UNITED STATES PATENT AND TRADEMARK OFFICE

APPLICATION NO.	FILING DATE	FIRST NAMED INVENTOR	ATTORNEY DOCKET NO.	CONFIRMATION NO.
10/602,547	06/24/2003	Kyle Bateman	2280.ACTLNP	1226
27472 7590 07/21/2008 BATEMAN IP LAW GROUP P.O. BOX 1319 SALT LAKE CITY, UT 84110				
EXAMINER CHAMBERS, TROY				
ART UNIT		PAPER NUMBER		
3641				
MAIL DATE		DELIVERY MODE		
07/21/2008		PAPER

Office Action Summary

DETAILED ACTION

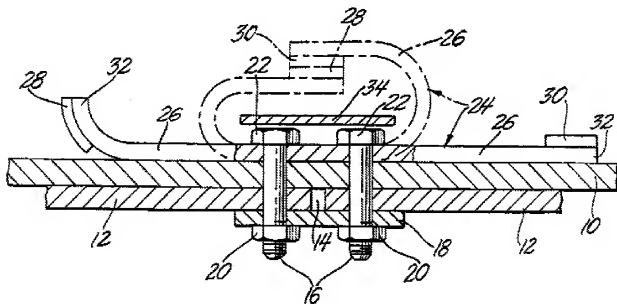
23. With respect to claim 12, Bateman discloses two pieces of plate steel 210; facing strip 214; mounting bracket 238; bolt and nuts 222, 234; and, bullet containment frame 250, 264, 268. At col. 7, lines 31-32, Bateman describes the connection of the nut and bolt as follows: "A bolt 222 extends from the facing strip 214 through the hole 218 in the backing strip 230." This disclosure says nothing about the bolt extending through the containment frame (250, 264, 268). Therefore, the attachment of the bolts to the facing strip and mounting bracket is not dependent upon the attachment of the containment frame which is apparently attached by some other method.

24. With respect to claim 13, Bateman discloses wood post 250 which is attached to the facing strip which is attached to the steel plates which is attached to the bracket. Therefore, the wood post is attached to the mounting bracket.

25. With respect to claim 16, Bateman discloses a wood post 250. The manner of making the post is of no consequence to an apparatus claim.
